# Citadel Update

## New Improved Citadel 4 Housing:

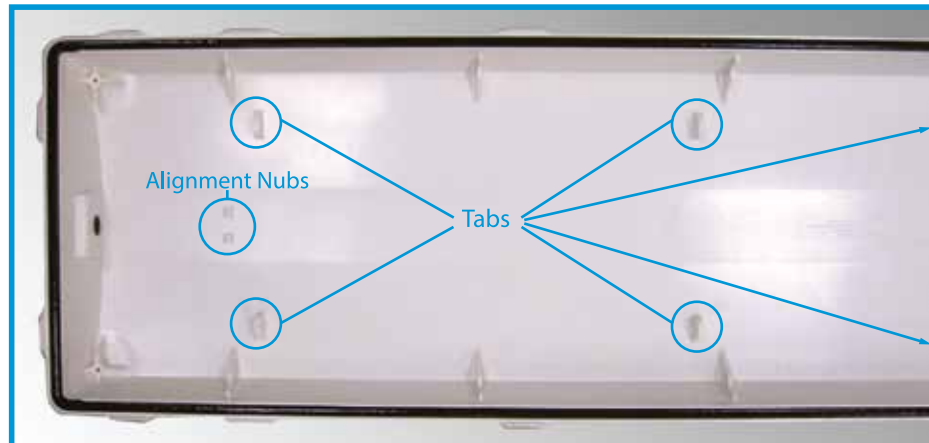
*Tabs for CT4-2XDAR!*

SLP will only offer the following housing for Citadel 4

### ○ CT4-HV5-2H

Includes  
6 tabs inside the housing  
for installation of the 2XDAR.

Alignment nubs at each end keep  
the 2XDAR centered

No New Part Number

### ○ CT4-2XDAR

Alternative to the CT4-HV5-2H-BR  
Equal Heat management

Holds up to 4 Drivers

Attaches to housing with 6 CT-2XDAR-CLIP

Supplies support for Pendant Mounting

\*Current Inventory of the CT4-HV5-2H Revision A will be depleted
